Application for Variation of an Environmental Permit

C2. Application No. of the Current Environmental Permit : AEP-534/2017

Project Title : Site Formation and Associated Infrastructural Works for Development of Columbarium, Crematorium and Related Facilities at Sandy Ridge Cemetery  
工程名稱：沙嶺墳場興建骨灰龕，火葬場及有關設施的工地平整及相關基建工程

Drawing title  
**FIGURE 1 : LOCATION PLAN**  
圖1：工程位置圖

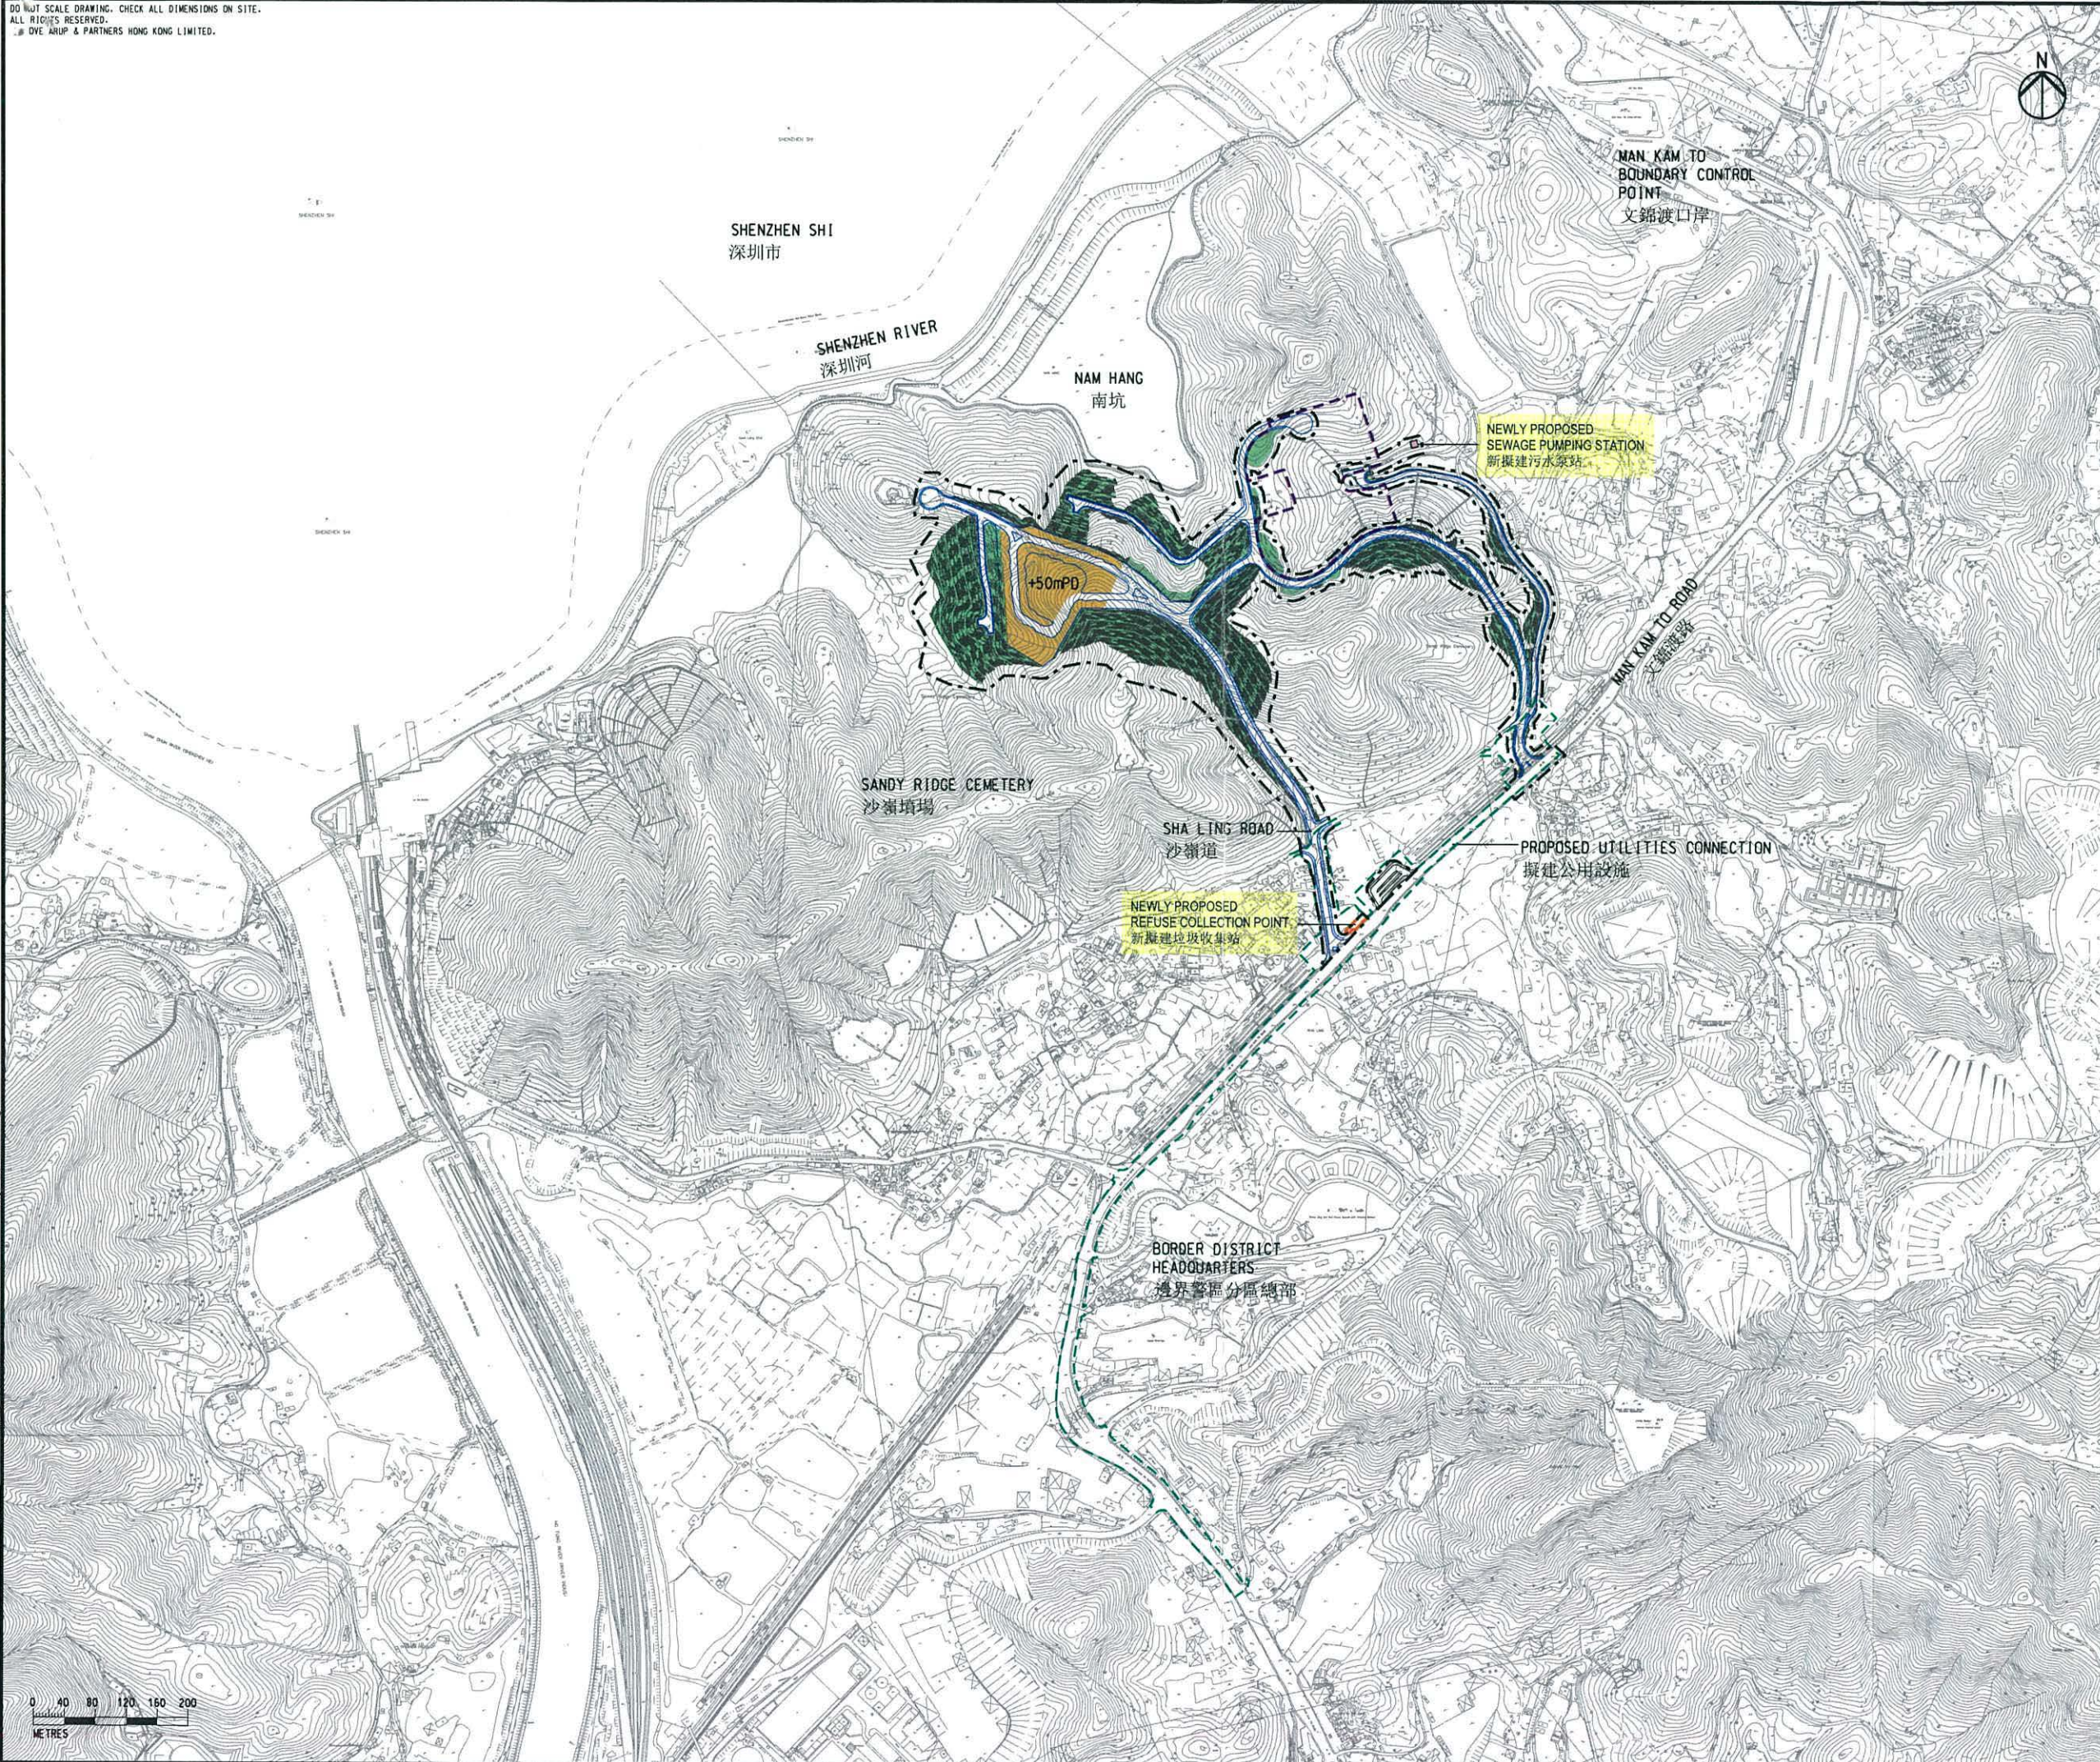
D1. Condition(s) in the Current Environmental Permit :	D2. Proposed Variation(s) :	D3. Reason for Variation(s) :	D4. Describe the environmental changes arising from the proposed variation(s) :	D5. Describe how the environment and the community might be affected by the proposed variation(s) :	D6. Describe how and to what extent the environmental performance requirements set out in the EIA report previously approved or project profile previously submitted for this project may be affected :	D7. Describe any additional measures proposed to eliminate, reduce or control any adverse environmental impact arising from the proposed variation(s) and to meet the requirements in the Technical Memorandum on Environmental Impact Assessment Process :
Figure 1	<p><u>Item 1 Removal of Original Platform for crematorium and adjustment of associated roadworks and slopeworks</u></p> <p>The original platform for crematorium has an area of about 2.5 ha. In order to facilitate the latest design, the original site for the crematorium will be shifted to the valley area to the immediate south of its original location and hence the original platform would not be required.</p> <p>Besides, as the latest design will take due consideration on the terrain characteristics, extensive site formation works would not be required anymore. Only building foundations / superstructures will be constructed.</p> <p>While extensive site formation works will not be required for the new crematorium site with site area of about 3 ha, some slopeworks outside but to the western portion of the new crematorium site and adjoining the new access road would be required. These slopeworks will be carried out by CEDD.</p> <p>(Note: As the construction and operation of crematorium is a Designated Project (DP) under Item N.4 of Schedule 2, Part I of EIAO, a separate EIA study will be conducted to fulfil all the statutory requirements and procedures under the EIAO.)</p> <p>The existing figure 1 in EP-534/2017 will be replaced by a revised figure 1 in the VEP application.</p>	Minimise the visual impact from crematorium upon neighbouring sensitive receivers.	<p>Refer to Section 3.2 to Section 3.10, Section 4.5, Section 5.4, Section 7.2, Section 8.1 and Section 9.1 in the VEP supporting document.</p> <p>Reduction in fugitive dust during construction phase. Changes to construction noise impacts at the identified NSRs. Reduction in amount of waste generated. Reduction in habitat loss and visual envelope.</p>	<p>Refer to Section 3.2 to Section 3.10, Section 4.5, Section 5.4, Section 7.2, Section 8.1 and Section 9.1 in the VEP supporting document.</p> <p>No adverse impacts on the environment and community from the proposed amendments.</p>	The impacts on all sensitive receivers will be reduced.	No additional mitigation measures required.

D1. Condition(s) in the Current Environmental Permit :	D2. Proposed Variation(s) :	D3. Reason for Variation(s) :	D4. Describe the environmental changes arising from the proposed variation(s) :	D5. Describe how the environment and the community might be affected by the proposed variation(s) :	D6. Describe how and to what extent the environmental performance requirements set out in the EIA report previously approved or project profile previously submitted for this project may be affected :	D7. Describe any additional measures proposed to eliminate, reduce or control any adverse environmental impact arising from the proposed variation(s) and to meet the requirements in the Technical Memorandum on Environmental Impact Assessment Process :
Figure 1 and Condition 2.21	<p><u>Item 2 Change in access road alignment with viaduct and additional of Emergency Vehicular Access (EVA)</u></p> <p>The original access road with slopeworks that connects the roundabout with Man Kam To Road will be shifted to the west, but the location of the intersection at Man Kam To Road remains the same. In addition, the original access road with a viaduct of about 300m long would be replaced by an at-grade road which is not classified as DP as per Schedule 2, Part I of the EIAO. The proposed access road will be about 7.3m wide (exclude pedestrian walkway). The majority of the width of the access road under the approved EIA report was of similar width, with the exception of the access road surrounding the crematorium platform (6m wide). The proposed EVA will be approximately 6m wide.</p> <p>The existing figure 1 in EP-534/2017 will be replaced by a revised figure 1 in the VEP application. Condition 2.21 in EP-534/2017 will be removed in the VEP application.</p>	<p>The crematorium has been relocated to the valley area which is at a level of about +12 mPD. The main entrance of the crematorium and related facilities building is located at about +40mPD. In order to comply with firefighting and rescue requirements, an EVA will be constructed by widening an existing road at the level of about 12 mPD to provide emergency access for the crematorium and related facilities. Proposed Sewage Pumping Station (SPS).</p>	<p>Refer to Section 3.2 to Section 3.10, Section 4.5 to Section 4.6, Section 5.4 to Section 5.5, Section 7.2, Section 8.1 and Section 9.1 in the VEP supporting document.</p> <p>No adverse air quality impacts during construction and operational phase. There are changes to the construction noise impacts and operational noise impacts at the identified NSRs. Reduction in amount of waste generated.</p>	<p>Refer to Section 3.2 to Section 3.10, Section 4.5 to Section 4.6, Section 5.4 to Section 5.5, Section 7.2, Section 8.1 and Section 9.1 in the VEP supporting document.</p> <p>No adverse impacts on the environment and community from the proposed amendments.</p>	<p>No changes for all the sensitive receivers during construction phase. Most of the sensitive receivers will be benefited during operational phase.</p>	<p>No additional mitigation measures required.</p>

D1. Condition(s) in the Current Environmental Permit :	D2. Proposed Variation(s) :	D3. Reason for Variation(s) :	D4. Describe the environmental changes arising from the proposed variation(s) :	D5. Describe how the environment and the community might be affected by the proposed variation(s) :	D6. Describe how and to what extent the environmental performance requirements set out in the EIA report previously approved or project profile previously submitted for this project may be affected :	D7. Describe any additional measures proposed to eliminate, reduce or control any adverse environmental impact arising from the proposed variation(s) and to meet the requirements in the Technical Memorandum on Environmental Impact Assessment Process :
Figure 1	<p><u>Item 3 Proposed Sewage Pumping Station (SPS)</u></p> <p>Proposed SPS with a capacity of about 70m<sup>3</sup>/day and located to the northeast of the proposed access road and EVA. Under the latest design, a proposed sewerage system will be constructed along the EVA. However, given the level difference along the EVA, it is not feasible to convey sewage generated from the crematorium and related facilities to the public sewerage system along the Man Kam To Road via gravity sewers. A SPS will be required to pump sewage from the crematorium and related facilities to the public sewerage system.</p> <p>The existing figure 1 in EP-534/2017 will be replaced by a revised figure 1 in the VEP application. The contingency measures for the proposed SPS (as listed under column D7) will be incorporated into the EP conditions.</p>	<p>Due to the level difference along the EVA, it is not feasible to convey sewage generated from the crematorium to the public sewerage system along the Man Kam To Road via gravity sewers. A SPS will be required to pump sewage from the crematorium to the public sewerage system.</p>	<p>Refer to Section 3.2 to Section 3.10, Section 4.5 to Section 4.6, Section 5.4 to Section 5.5, Section 6.1, Section 7.2, Section 8.1 and Section 9.1 in the VEP supporting document.</p> <p>No adverse construction or operational air quality and noise impacts arising from the proposed SPS. There would be potential operational water quality impacts in the remote event of emergency discharge.</p>	<p>Refer to Section 3.2 to Section 3.10, Section 4.5 to Section 4.6, Section 5.4 to Section 5.5, Section 6.1 to Section 6.2, Section 7.2, Section 8.1 and Section 9.1 in the VEP supporting document.</p> <p>No adverse impacts on the environment and community from the proposed amendments.</p>	<p>Insignificant change on environmental performance.</p>	<p>To prevent the occurrence of emergency discharge, the following contingency measures should be implemented:</p> <ul style="list-style-type: none"> <li>- Emergency storage tank;</li> <li>- Monitoring and Control System;</li> <li>- One standby pump;</li> <li>- Twin rising mains;</li> <li>- Sewage tanker vehicles;</li> <li>- One standby mechanical bar screen;</li> <li>- A bar screen in front of emergency discharge pipe;</li> <li>- Contingency plans with reference to relevant guidelines from EPD and DSD; and</li> <li>- Regular maintenance and checking of plant equipment.</li> </ul>

D1. Condition(s) in the Current Environmental Permit :	D2. Proposed Variation(s) :	D3. Reason for Variation(s) :	D4. Describe the environmental changes arising from the proposed variation(s) :	D5. Describe how the environment and the community might be affected by the proposed variation(s) :	D6. Describe how and to what extent the environmental performance requirements set out in the EIA report previously approved or project profile previously submitted for this project may be affected :	D7. Describe any additional measures proposed to eliminate, reduce or control any adverse environmental impact arising from the proposed variation(s) and to meet the requirements in the Technical Memorandum on Environmental Impact Assessment Process :
Figure 1	<p><u>Item 4 Proposed Refuse Collection Point (RCP)</u></p> <p>Proposed RCP located at the junction of Man Kam To Road and Sha Ling Road.</p> <p>The existing figure 1 in EP-534/2017 will be replaced by a revised figure 1 in the VEP application.</p>	<p>The existing RCP will be affected by the construction works and the new RCP is proposed to be located at the junction of Man Kam To Road and Sha Ling Road.</p>	<p>Refer to Section 3.2 to Section 3.10, Section 4.5 to Section 4.6, Section 5.4, Section 6.1, Section 7.2, Section 8.1 and Section 9.1 in the VEP supporting document.</p> <p>No adverse changes to the air quality, noise or water quality impacts during the construction and operational phase.</p>	<p>Refer to Section 3.2 to Section 3.10, Section 4.5 to Section 4.6, Section 5.4, Section 6.1, Section 8.1 and Section 9.1 in the VEP supporting document.</p> <p>No adverse impacts on the environment and community from the proposed amendments</p>	<p>Insignificant change on environmental performance.</p>	<p>No additional mitigation measures required.</p>

D1. Condition(s) in the Current Environmental Permit :	D2. Proposed Variation(s) :	D3. Reason for Variation(s) :	D4. Describe the environmental changes arising from the proposed variation(s) :	D5. Describe how the environment and the community might be affected by the proposed variation(s) :	D6. Describe how and to what extent the environmental performance requirements set out in the EIA report previously approved or project profile previously submitted for this project may be affected :	D7. Describe any additional measures proposed to eliminate, reduce or control any adverse environmental impact arising from the proposed variation(s) and to meet the requirements in the Technical Memorandum on Environmental Impact Assessment Process :
Figure 1	<p><u>Item 5 Additional construction works for utilities connection along Man Kam To Road</u></p> <p>Additional construction works for utilities connection along Man Kam To Road between Sha Ling Road and the proposed access road.</p> <p>The existing figure 1 in EP-534/2017 will be replaced by a revised figure 1 in the VEP application.</p>	<p>The additional utilities connection is required to connect the proposed sewers and water mains from the crematorium to the public sewerage system and the water supply system along Man Kam To Road.</p>	<p>Refer to Section 3.2 to Section 3.10, Section 4.5, Section 5.4, Section 7.2, Section 8.1 and Section 9.1 in the VEP supporting document.</p> <p>Increase in construction noise impact arising from the cumulative construction works.</p>	<p>Refer to Section 3.2 to Section 3.10, Section 4.5, Section 5.4, Section 7.2, Section 8.1 and Section 9.1 in the VEP supporting document.</p> <p>No adverse impacts on the environment and community from the proposed amendments.</p>	<p>No change for all the sensitive receivers during construction and operational phases.</p>	<p>No additional mitigation measures required.</p>
